OLDLANDS BUSINESS PARK – BOGNOR REGIS

STAGE ONE SAFETY AUDIT

Designers Response

The following document addresses the issues raised in the Stage 1 Safety Audit carried out on 11th December 2007 by Road Safety Consulting Ltd – Ref:RSC/MKG/---/Bognor. This response is to be read in conjunction with drawings 0704/13 which details changes made in response to the Safety Audit and 0704/13A which details junction visibility splays.

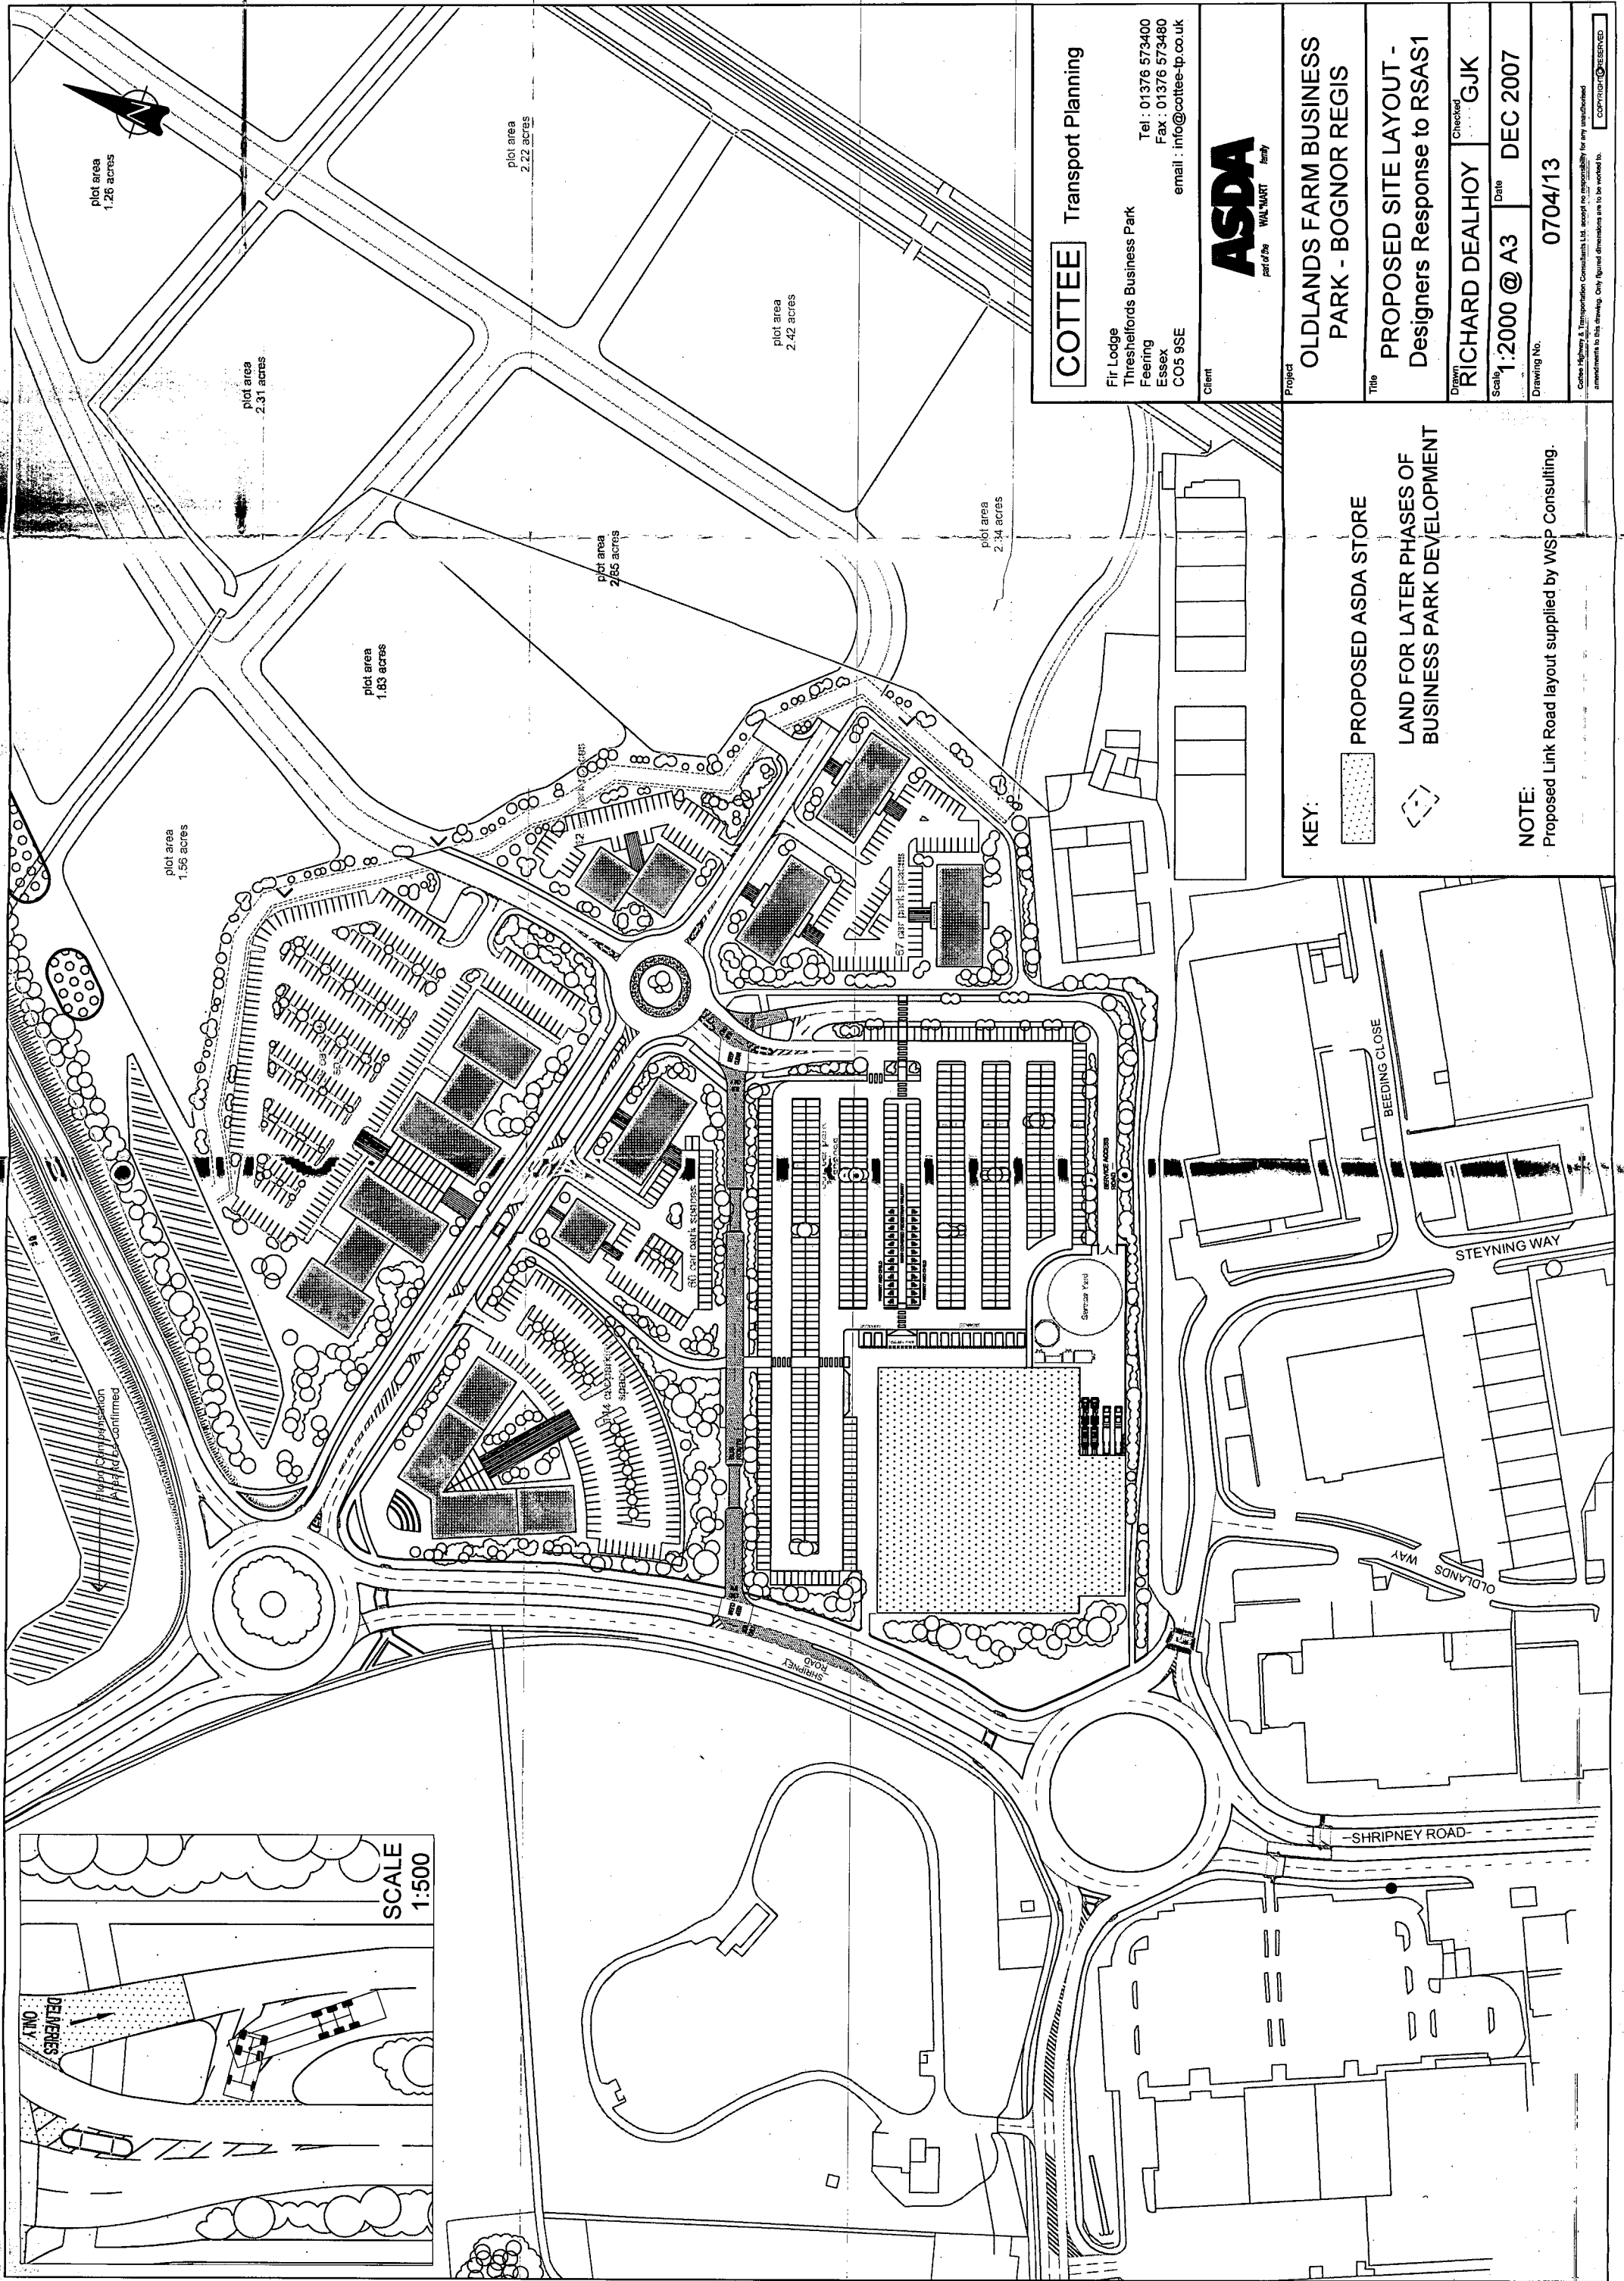
Ramp sited close to roundabout

Long single crossing

The raised pedestrian surface has been moved 8.5m west (also addresses Problem 2.3.2).

Pedestrian raised crossing has been moved 8.5m east as stated in the response to problem 2.1.3 to create a shorter crossing width with better visibility to vehicles exiting the roundabout.

Drawing No.
0704/13A

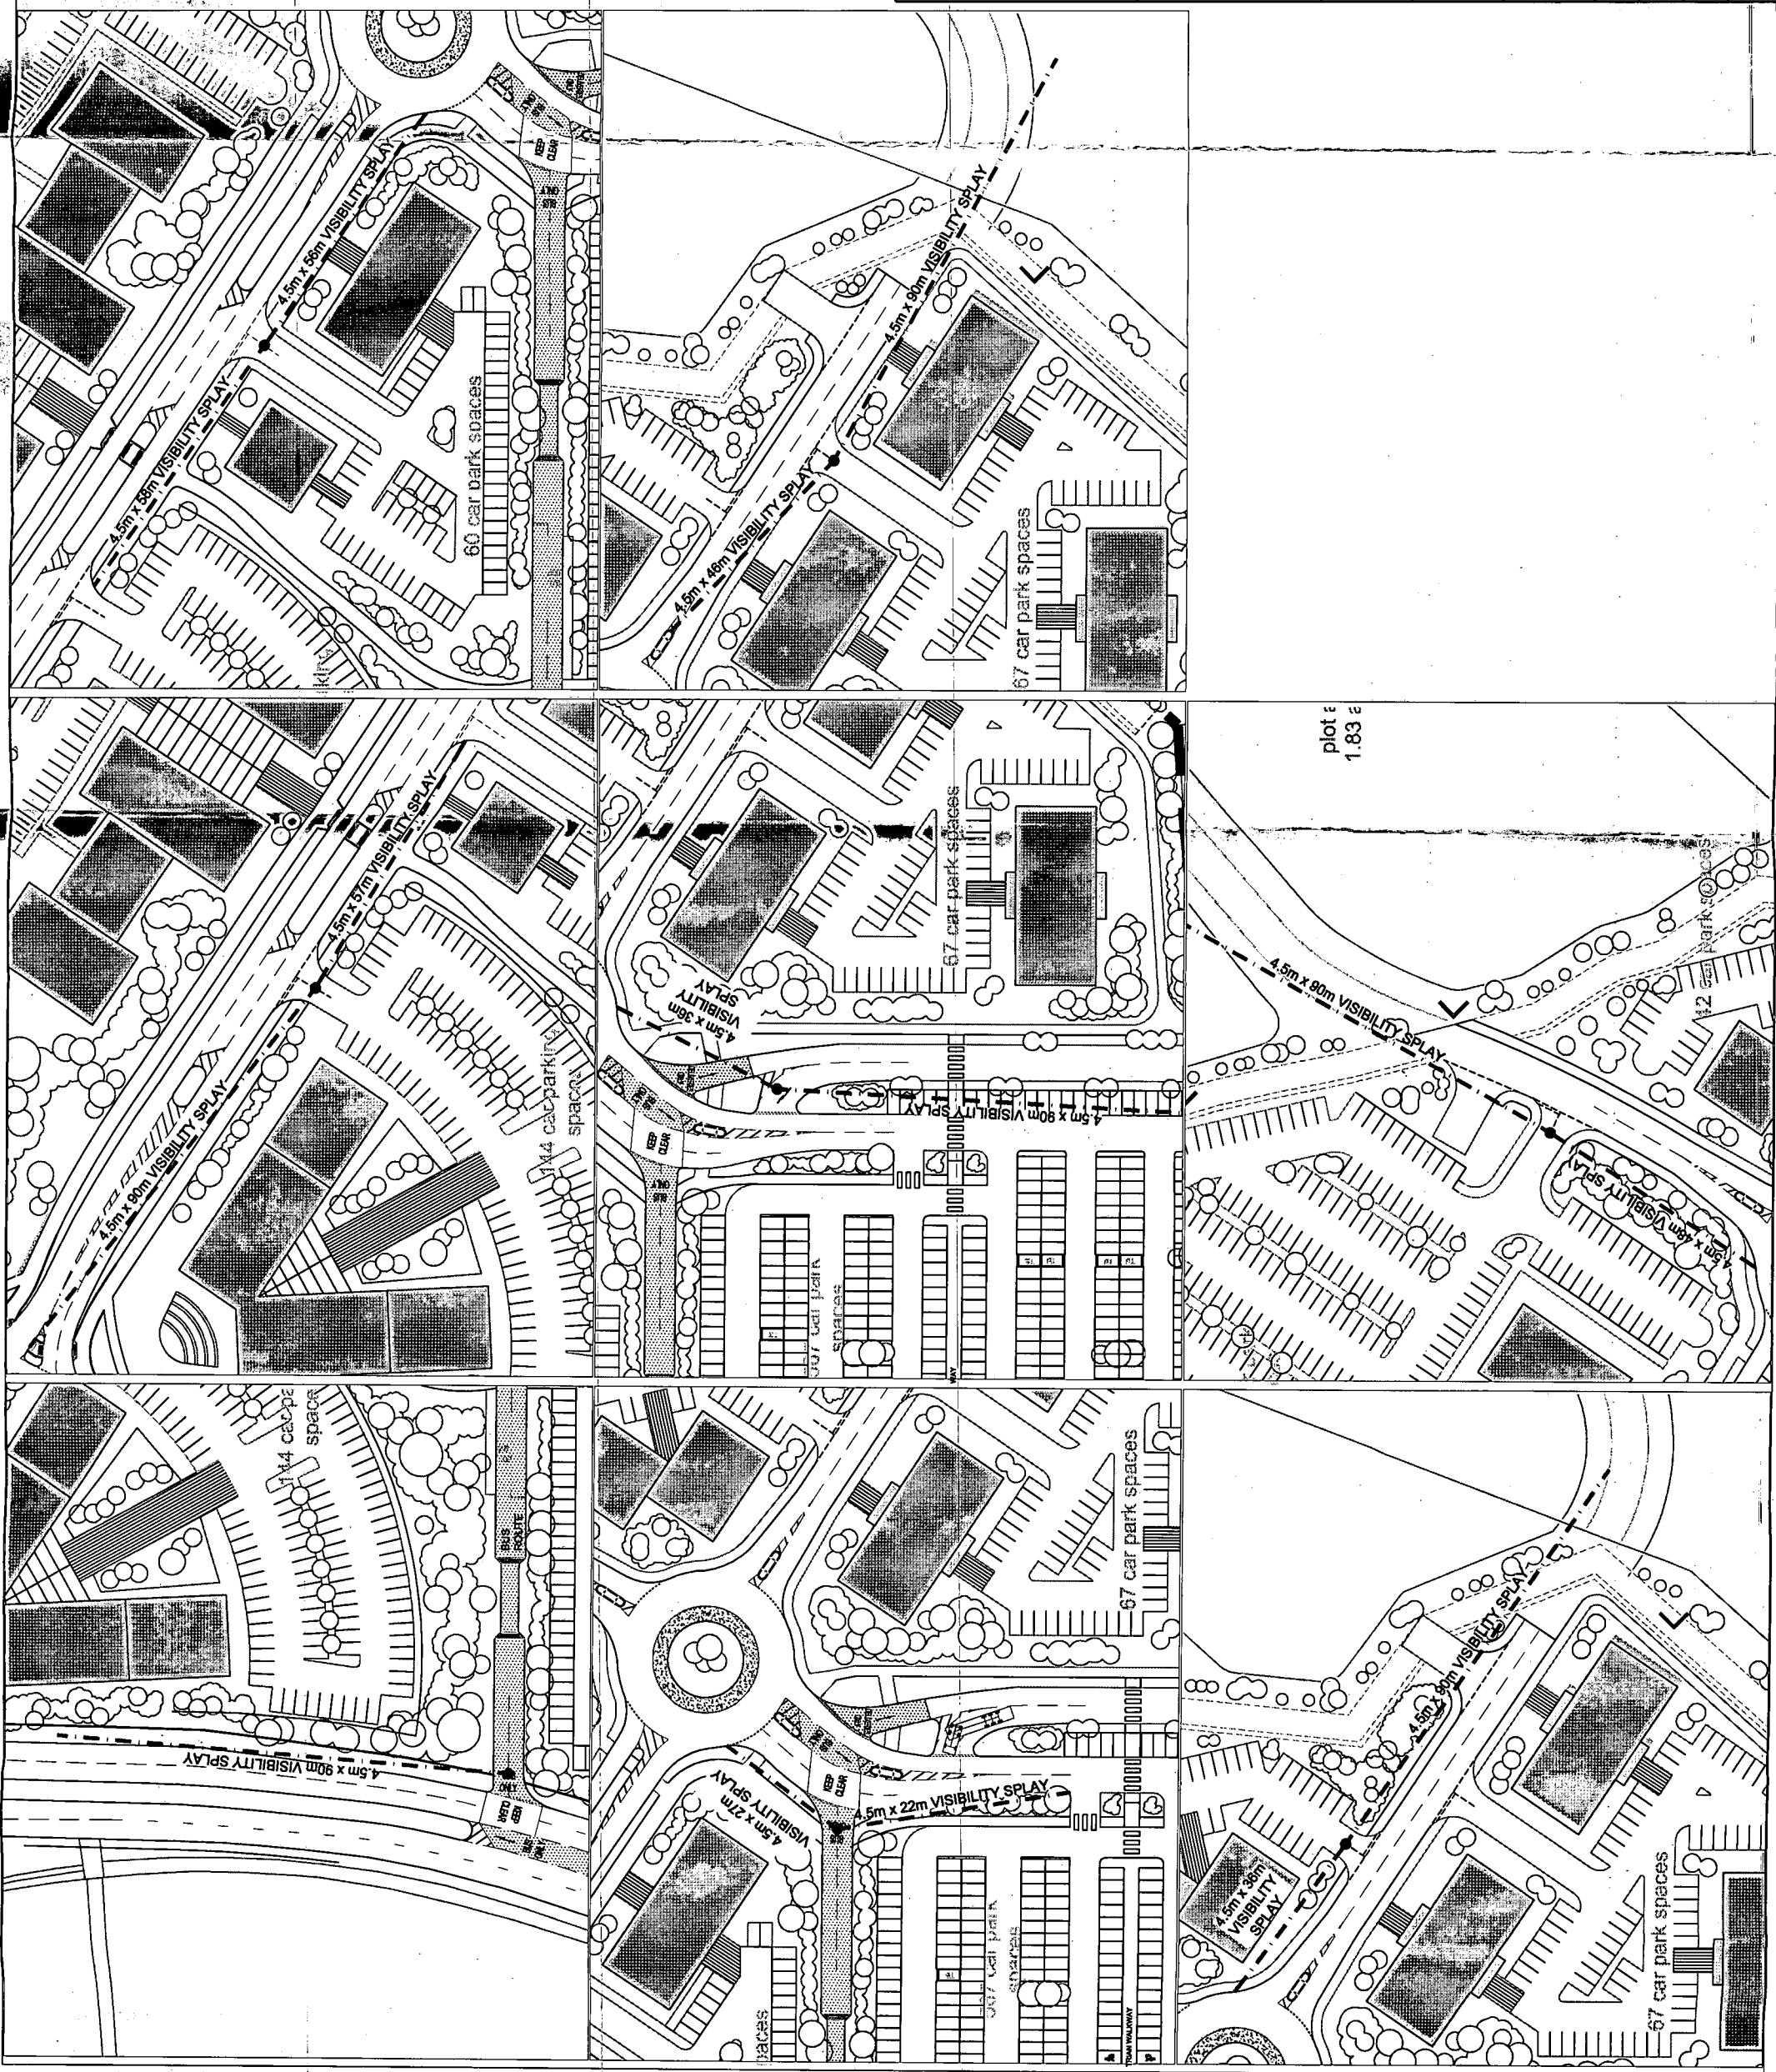
Visibility for exiting driver

As shown on drawing 0704/13 the vehicle cab is almost perpendicular to the giveway line when exiting the service road, which affords the driver the prescribed 90m visibility to the left and up to the roundabout access to the right.
